# UNITED STATES PATENT AND TRADEMARK OFFICE

APPLICATION NO.	FILING DATE	FIRST NAMED INVENTOR	ATTORNEY DOCKET NO.	CONFIRMATION NO.
10/696,757	10/29/2003	John A. Sollars JR.	2056B	6684

## Office Action Summary

## DETAILED ACTION

Entry Not  
Approved  
EC  
11/22/05

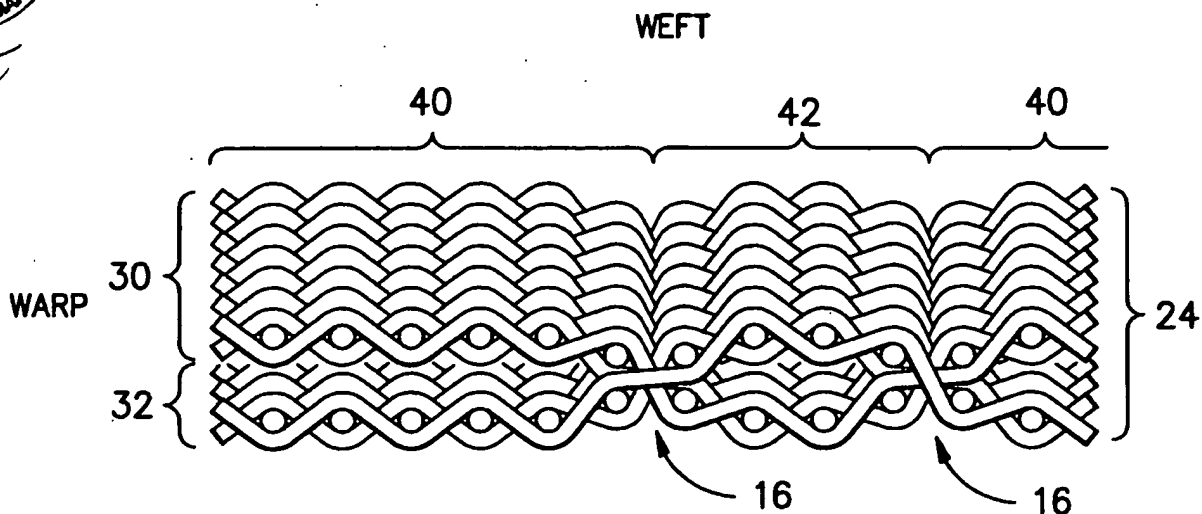
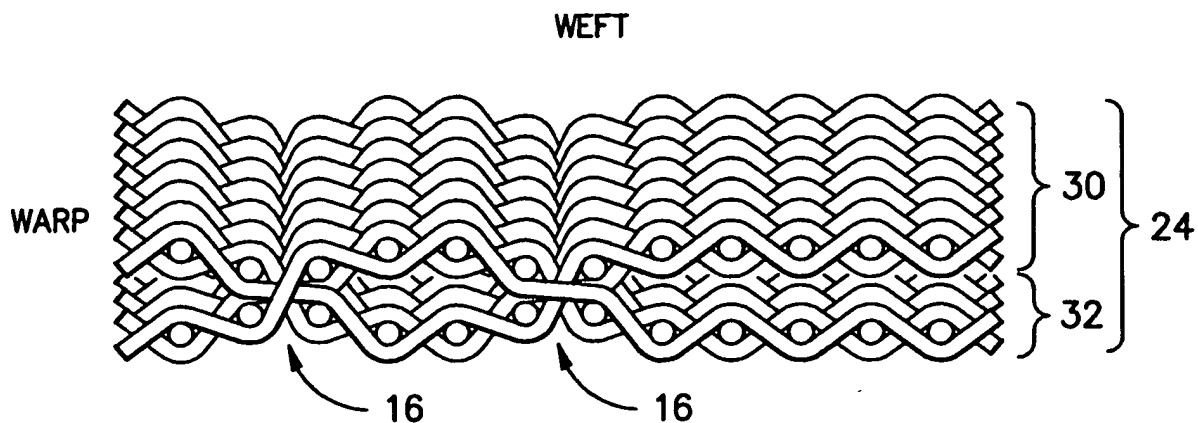
1. The drawings were received on 9/16/05. These drawings are not acceptable.
  - a. The drawing of Figure 11 constitutes new matter (there is no support in the original disclosure for the exact curved shape of joints 16'). The deficiency may be obviated by specifying in the description of Figure 11, say on page 19 where Figure 11 is described, that it is a "schematic" representation (i.e., not conveying exact structure or location). If this were done, it would not be necessary to resubmit drawings.
  - b. Also, a Brief Description of Figure 11 should be added to page 8 of the specification.
  - c. In Figure 1, the arrow heads and lead lines for reference numerals 14 do not align (i.e., the arrowheads are just floating on the figure).
